# Service Bulletin

S.B. No: 092

**Title:** INSPECTION AND RECTIFICATION OF FUEL VENT AND HYDRAULIC RESERVOIR TUBE, PLUS VENT PIPE INLET RE-ORIENTATION

FIGURE 1

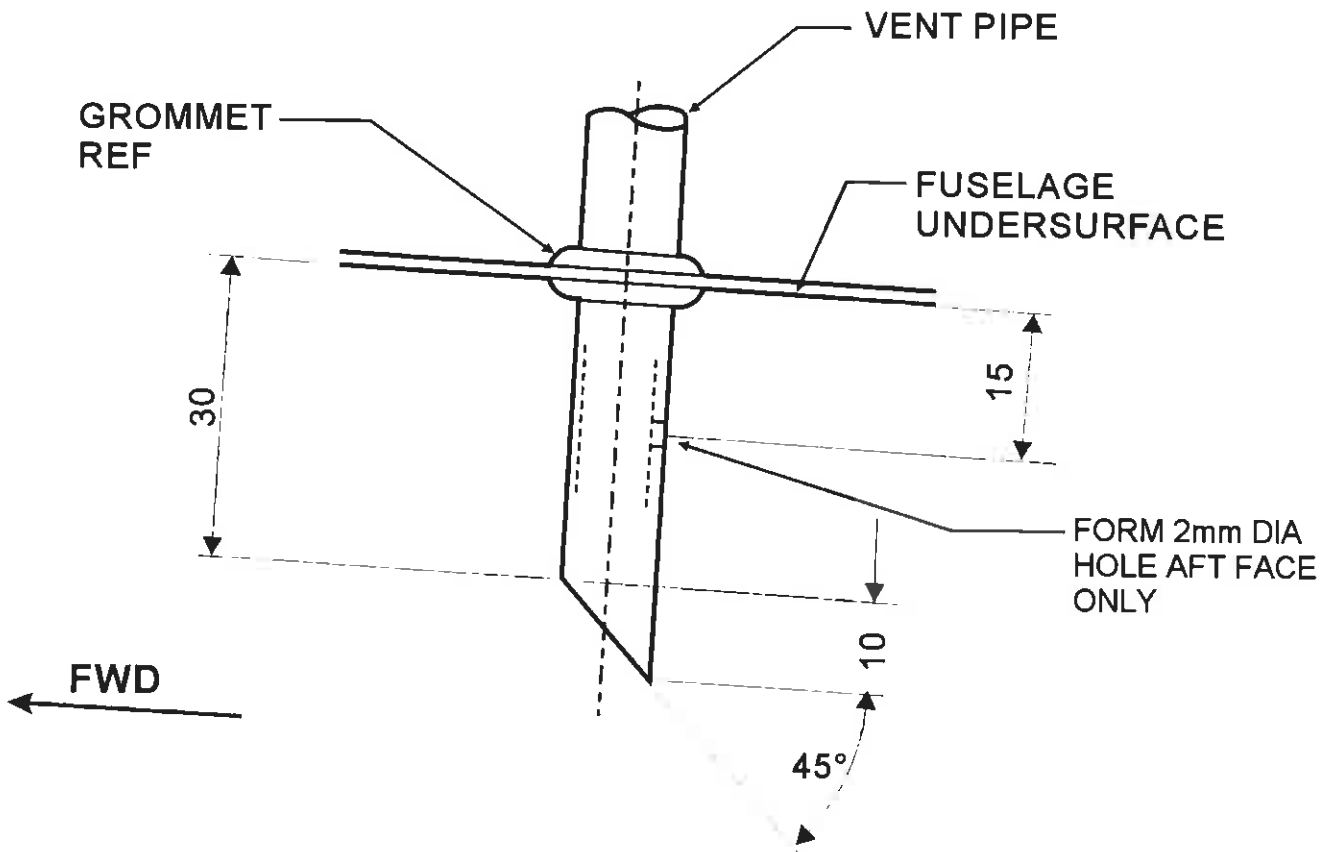
During the course of this inspection, ref. T67M260-T3A, ensure the vent pipe inlets are facing forward ref. Figure 1. The pipes are to be re-orientated through 180° to minimise the possibility of fuel in the vent line draining from the aircraft during flight. This action invokes a modification, Mod M701.

1. **T67M260-T3A only.** Inspect the fuel tank vent pipes below the centre section.
  - i. If the vent pipes are found to be stiff and hard, replace.
  - ii. If the vent pipes do not appear to have a yellow cast to them, replace.
  - iii. If in doubt, replace.
2. Vent pipe inspection:
  - 2.1 **T67M260-T3A only.** During inspection or during course of replacement, re-fit vent tubes with opening facing forward. Form (see paragraph 2.3 below) Ø2mm diameter hole in aft face. Ref. Figure 1.

This action invokes Modification M701. Annotate in aircraft logbook "Mod M701 incorporated.
  - 2.2 T67C wing tank (Post Mod M156) only, T67M-MkII, T67M200 and T67M260. Inspect the fuel vent pipe for correct orientation and configuration, ref. Figure 1. If incorrect, re-assemble as shown. If necessary fit new item (SAL Stock Code 126-36-002, length 230mm), to the configuration shown in Figure 1, ensuring vent tubes opening faces forward and 2mm diameter hole is in aft face.

This action invokes Modification M701. Annotate in aircraft logbook "Mod M701 Incorporated if applicable
  - 2.3 **All aircraft.** Check the Ø2mm hole for correct size, if it is undersize, and then remove pipe and open hole up until it is of the correct diameter. This may be done by using oversize drill or oversize punch or forming with hot needle of the appropriate size.

Whichever method is employed it is recommended that the rework of the pipe is done off the aircraft; that if in doubt trial on scrap piece of vent pipe and ensure pipe is not damaged during rework.
  - 2.4 It is recommended that at every annual that the Ø2mm hole is checked for correct size and rectify as per paragraph 2.3 if applicable.
  - 2.5 Ensure during replacement of vent tube during the course of the aircrafts service that the vent pipes are fitted IAW this Service Bulletin, ref. Fig. 1.
  - 2.6 **All aircraft.** Ensure wing seals are correctly fitted, rectify or replace as required.
